**Amendments to the Drawings:**

## REMARKS

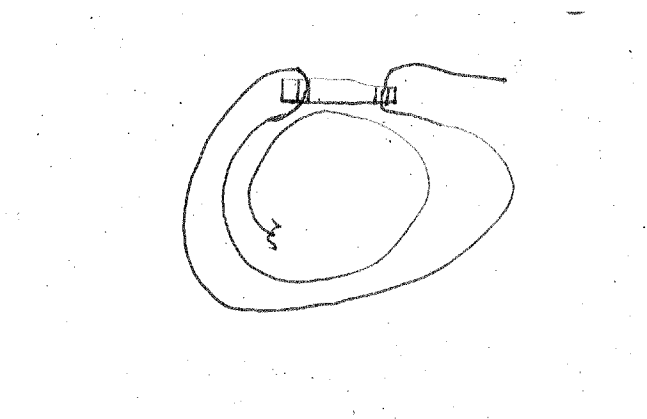
The sheet of drawing containing Figure 3 has been amended to add a Figure 3A illustrating a carabineer hook. Support for this figure can be found in paragraphs [0007] and [0018] of the specification and in claim 4.

The drawings are objected to under 37 C.F.R. § 1.83(a) because the drawings failed to show the carabiner hook as recited in claim 4. Enclosed is an amended sheet of drawing adding a figure 3A showing the hook as a carabiner hook.
